FILE FOR

RAPID PROTO

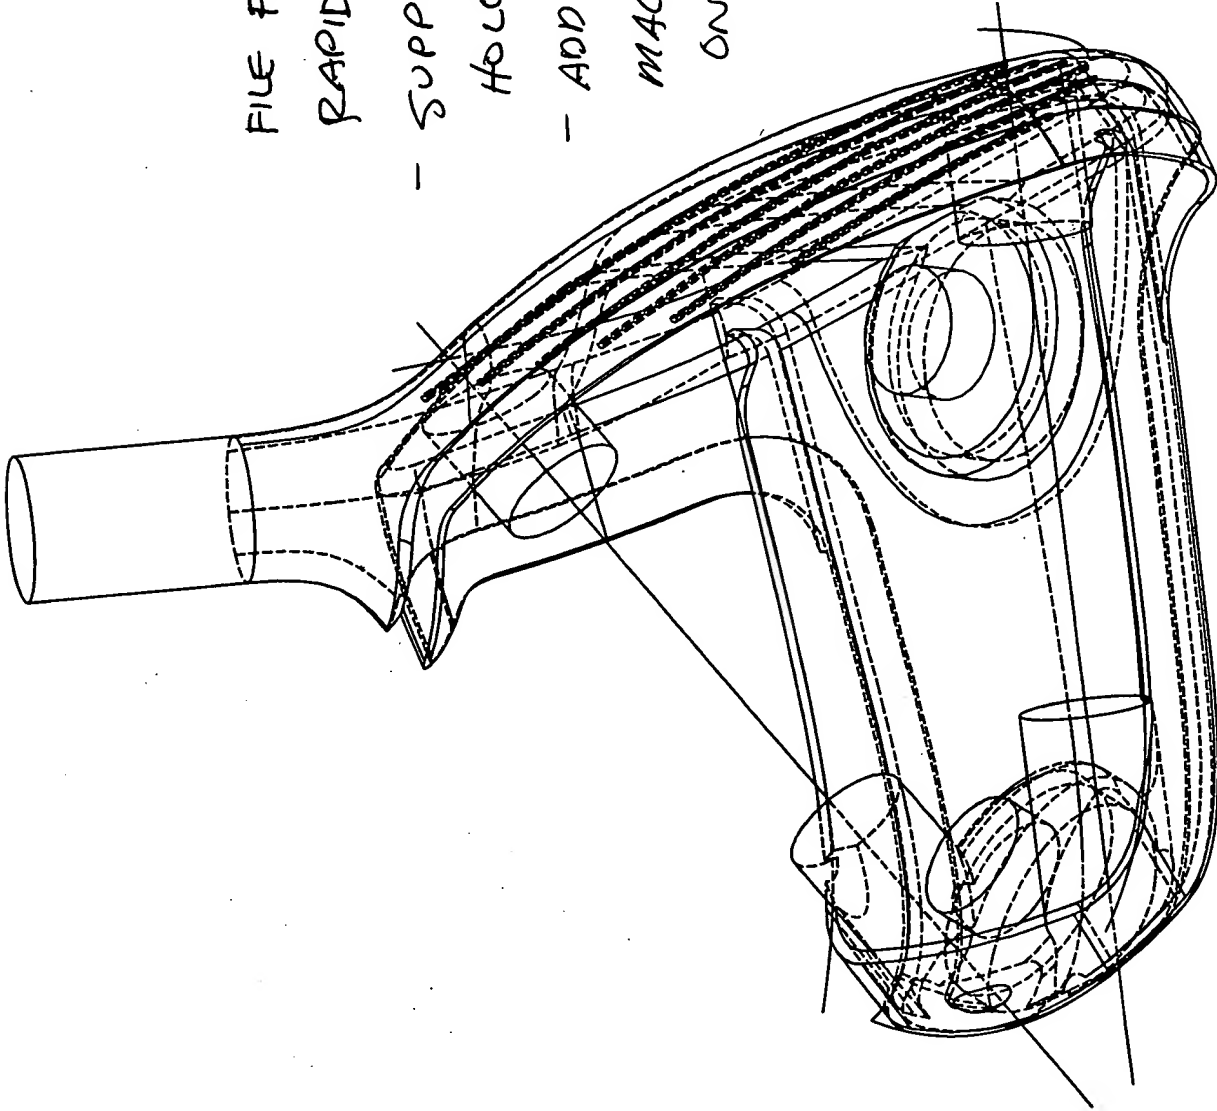
- SUPPRESS

HOLES

- ADD .5mm

MACH STOCK

ON PLUG BOSSE
